Access Compliance Report

Public Rights-of-Way (Curb Ramps)

Intersection ID: 51630	Main Street: STEELECROFT_PY	Cross Street: CLOISTERS_CLUB_LN	Location: SE
ADA ID: 1CCA7A221436	Ramp Type: Directional1	Initial Pass/Fail: Fail	Overall Compliance: No
		Severity Score: 1.25

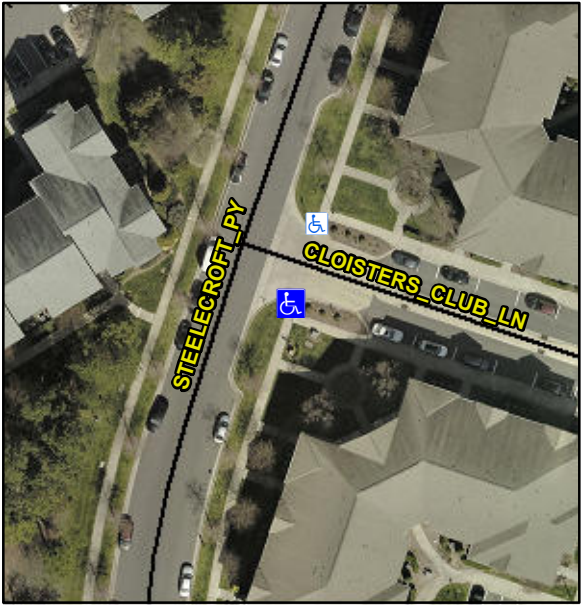
Codes/Mitigation Info/Possible Solution		Field Measurements/Component Compliance			
 <p>Street 1 Name CLOISTERS CLUB LN</p> <p>Stop Condition-Street 1 StopSign</p> <p>Street 2 Name N/A</p> <p>Stop Condition-Street 2 N/A</p>	Possible Solutions:	Remove & Replace Entire Ramp.			
	Surveyor Notes:	N/A			
	PROW/ADA:	R304.5.3			
			Compliance	Description	Data
			N/A	Ramp Length (in)	48.0
			Yes	Ramp Width (in)	59.0
			Yes	Ramp Slope (%)	1.6
			No	Ramp XSlope (%)	3.8
			N/A	Flare Type LT	N/A
			N/A	Flare Slope LT (%)	N/A
			N/A	Flare Traversable LT?	N/A
			N/A	Landing Length (in)	0.0
			N/A	Landing Width (in)	0.0
			N/A	Landing Slope (%)	0.0
			N/A	Landing X Slope (%)	0.0
			N/A	Landing Curb? (Y/N)	N/A
			N/A	Shared Landing?	N/A
			N/A	Gutter Ponding?	0.0
			N/A	Gutter Lip Ht (in)	0.0
			N/A	Painted X Walk1?	No
				X Walk 1 Direction	To N
				X Walk 1 Width (in)	N/A
				X Walk 1 Slope (%)	0.6
				X Walk 1 X Slope (%)	0.7

N/A	Ramp inside XWalk1?	N/A
			N/A	Any Obstructions?	N/A
				Obstruction Type	
			Yes	Surface Condition? (G/P)	Good
			N/A	Curb Slope (%)	13.4
Total Cost:		\$ 1600.00
